# Design Change Notification

**Document #:** DCN-133

**Subject:** Orca Generator changing from WEG to KWG.

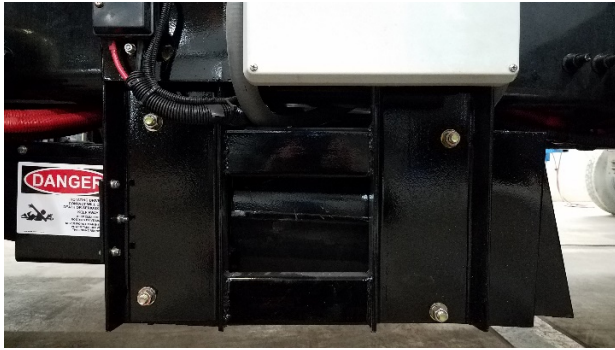
**Background:** Chart currently offers a WEG generator for any Orca models that are mounted to a chassis. Chart will be moving to a new, more reliable brand of generator, KWG. This generator will be standard on any new production Orcas effective, March 4th, 2021. Any Gen 1 units that are upgraded to the Gen 2 design will come equipped with a KWG generator. The KWG comes with a two-year warranty vs the WEG, which offered a one-year warranty.

**Description:** The new KWG generator was chosen after many months of evaluation and testing. Chart vetted numerous candidates and felt that KWG offered the best product for our application. The KWG offers a substantial benefit over the WEG. The KWG provides better protection from the elements due to the generator being fully enclosed and IP67 rated. Ample stock of the KWG generators will be stored in South Carolina and be available for quick shipments as needed to ensure minimal downtime. Testing has been conducted to prove that the KWG generator meets all performance specifications for the products it will be used on. Chart has also developed a WEG to KWG retrofit kit that will enable customers who currently have a WEG generator to change to a KWG generator if they choose.

WEG	
11872285	Generator WEG 26KVA
13009645	Generator WEG 38KVA
KWG	
21464028	Generator KWG 28KVA
21464029	Generator KWG 38KVA
Retrofit Kits	
21737181	WEG to KWG Retrofit Kit (38 KVA)
21874046	WEG to KWG Retrofit Kit (28 KVA)
